**State Significant Development Application and Variation of the Sydney Cove Redevelopment Scheme for the “*Remediation, Renewal and Adaptive Re-Use of Campbell’s Stores*”, The Rocks (SSD 7056)**

We write in response to the above development application (DA) and request to vary the Sydney Cove Redevelopment Authority Scheme (SCRAS) submitted to the Minister for Planning by Tallawolodah Pty Ltd for proposed works to the Campbell’s Stores at The Rocks.

Figure 1: Extract from the CMP showing (in pink) the heritage curtilage for the Campbell's Stores. The area to the far right within the pink area is 'Bay 12', the area between Campbell's Stores and the Park Hyatt hotel.

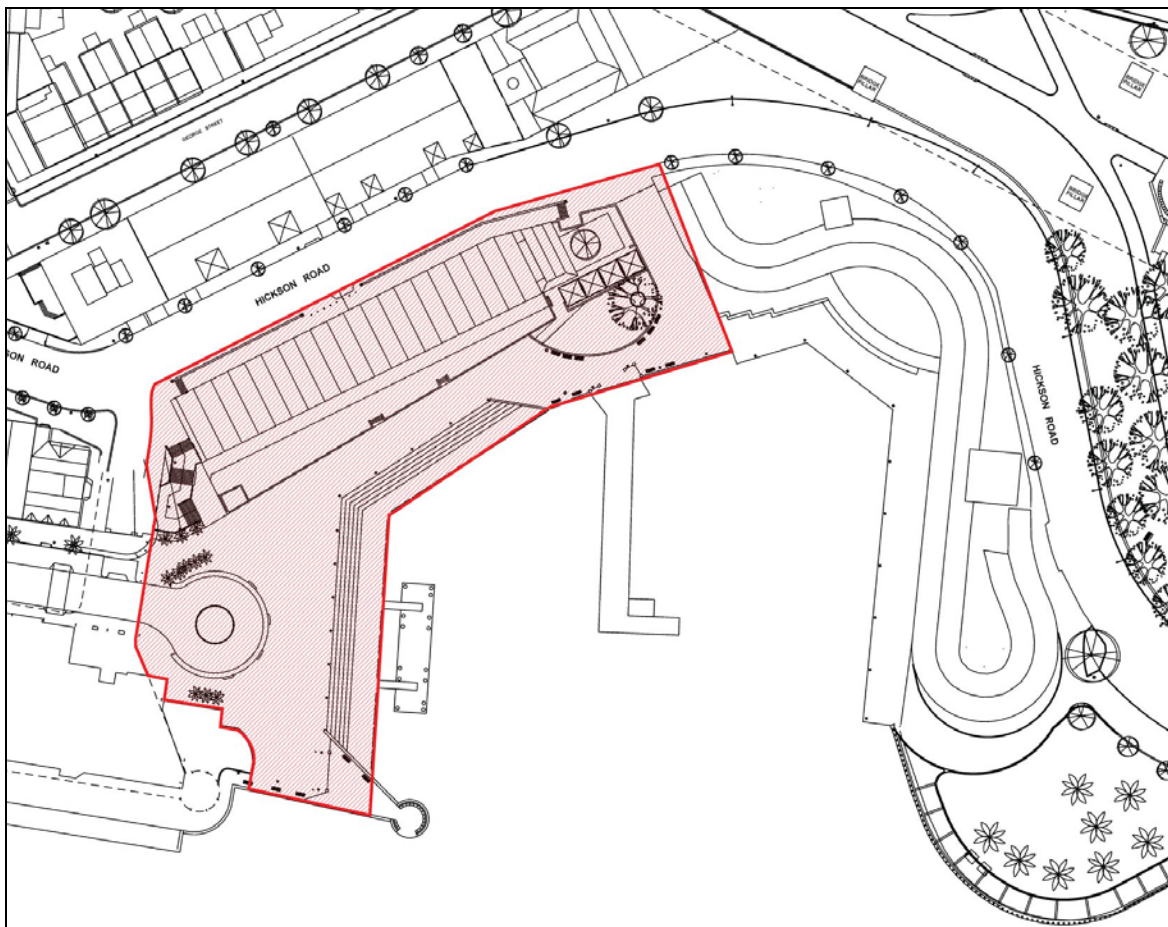
The CMP delineates the physical setting - the required heritage curtilage of the Campbell's Stores. It extends from the Overseas Passenger Terminal overpass to the Park Hyatt Hotel and incorporates the pavilion to the north of Bay 11, which the proponent refers to as 'Bay 12' (even though the adopted CMP makes no reference to Bay 12). This heritage curtilage is essential for retaining and interpreting the building's historic significance as it underpins the building's visual setting, views and context. It should contain all elements contributing to the heritage significance, conservation and interpretation of the Stores and should not have other structures impinging on and undermining this.

*Figure 2: Site location and context. 8 Hickson Road is located directly opposite the Campbell's Stores and the proposed new "Bay 12" Glass Box. Note the Cruise ship located at the Overseas Passenger Terminal and the historic Bond Metcalfe in close proximity to the Campbell's Stores.*

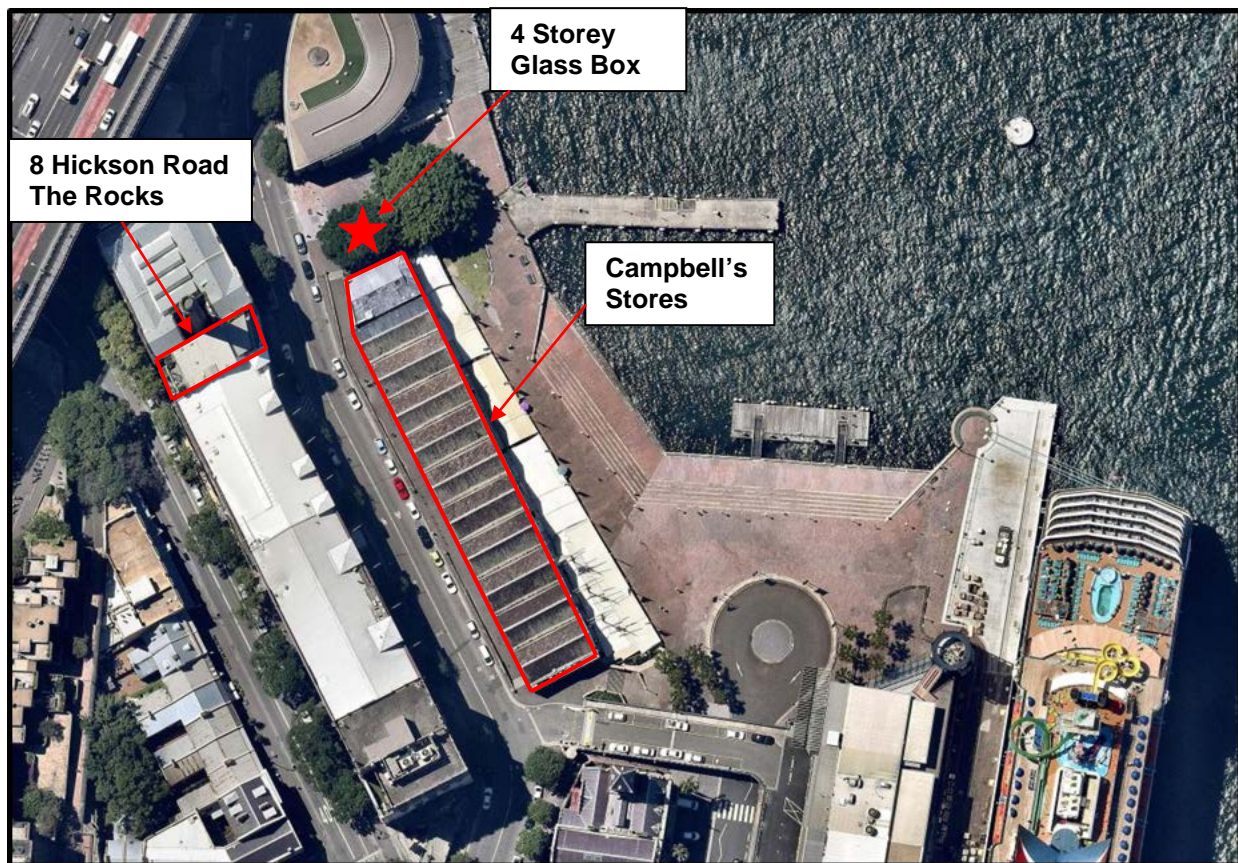
8 Hickson Road The Rocks is located next to the historic Bond Metcalfe, in very close proximity to the subject development site, directly to the west, on the opposite side of Hickson Road. At the closest point, the two buildings are located within 20m of each other. The closest building element of the subject development is Bay 11 and the proposed new glass building. These neighbouring buildings are located in an historic and bustling urban environment and within a short distance of one another.
